# UNITED STATES PATENT AND TRADEMARK OFFICE

APPLICATION NO.	FILING DATE	FIRST NAMED INVENTOR	ATTORNEY DOCKET NO.	CONFIRMATION NO.
10/779,732	02/18/2004	Thierry Zami	Q79774	2082
23373	7590	07/11/2005	EXAMINER	
SUGHRUE MION, PLLC 2100 PENNSYLVANIA AVENUE, N.W. SUITE 800 WASHINGTON, DC 20037			ULLAH, AKME	
			ART UNIT	PAPER NUMBER
			2874

<b>Office Action Summary</b>	Application No. 10/779,732	Applicant(s) THIERRY ZAMI	
	Examiner Akm Enayet Ullah	Art Unit 2874

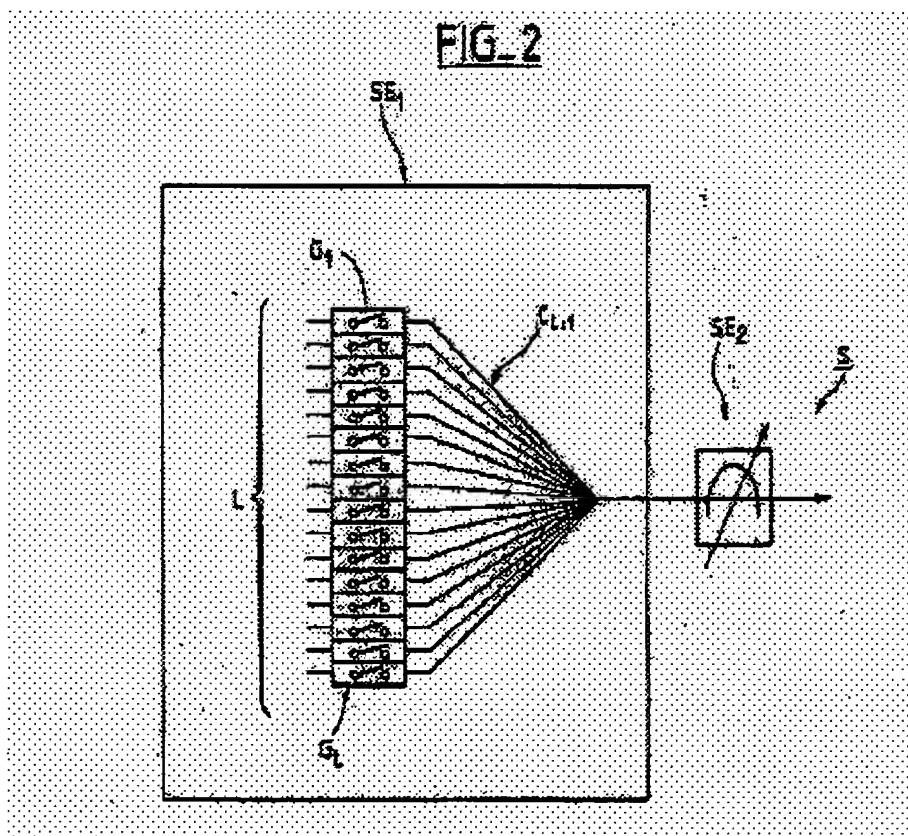
Claims 1 - 4 and 7 are rejected under 35 U.S.C. 102(b) as being clearly anticipated by Admitted Prior Art (figures 1-2).

Note that Figure 2 clearly teaches the claimed subject matter as claimed in claims 1-4 and 7. The spatial selector SE1 and SE2, SE1 selector comprises L is an optical ports G1, optical coupler , optical gate i.e., optical switch, L inputs receive a WDM signal, special selector SE2 comprises a demultiplexer, a multiplexer, SE1 send to its output only one of the L signals Ft which is received and an amplifier At. For details see Background of the Invention.
